### REMARKS

The applicants have studied the Office Action dated August 27, 2003, and have made amendments to the claims. It is submitted that the application, as amended, is in condition for allowance. By virtue of this amendment, claims 1-11 and 21-23 are pending. Claims 1 and 8 should be amended, and new claims 21-23 should be added. Consideration and allowance of all of the claims in view of the above amendments is respectfully requested.

FIG. 2

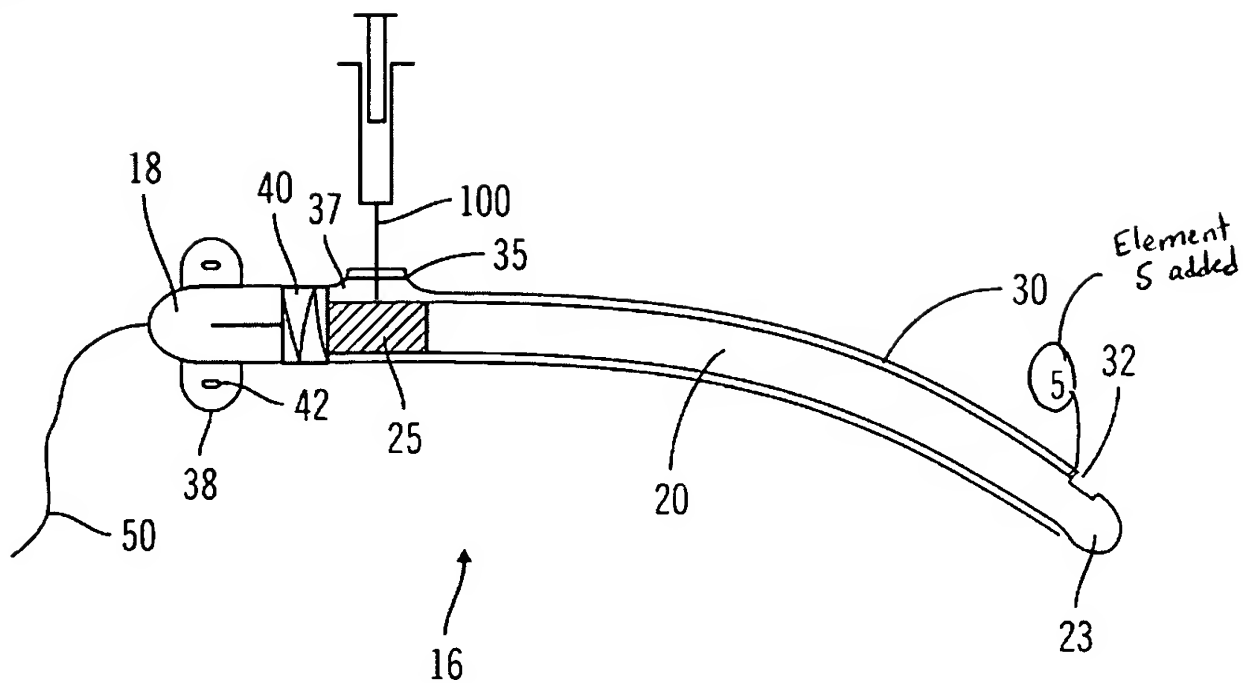
The drawings were objected to under 37 CFR 1.83(a) because the Examiner believes that the limitation found in claim 5 was not shown in the drawings. Moreover, claim 5 was further objected to under 37 CFR 1.75(d) (1) and MPEP § 608.01(o) for failing to provide proper antecedent basis for the claimed subject matter (i.e. there is no disclosure of the subject matter of the one-way valve). These objections are respectfully traversed.

Figure 2 has been amended to include element 5 (i.e. the one-way valve). Moreover, antecedent is found in the specification for the one-way valve in paragraph [0022], which states: "around the sensor tip 23, the flush sleeve 30 contains a small orifice 32, which comprises a one-way valve 5, to allow fluid to spray off the sensor tip 23" (emphasis added). Accordingly, it is respectfully submitted that the objection to the drawings and the objection under 37 CFR 1.75(d) (1) and MPEP § 608.01(o) are overcome and should be withdrawn.
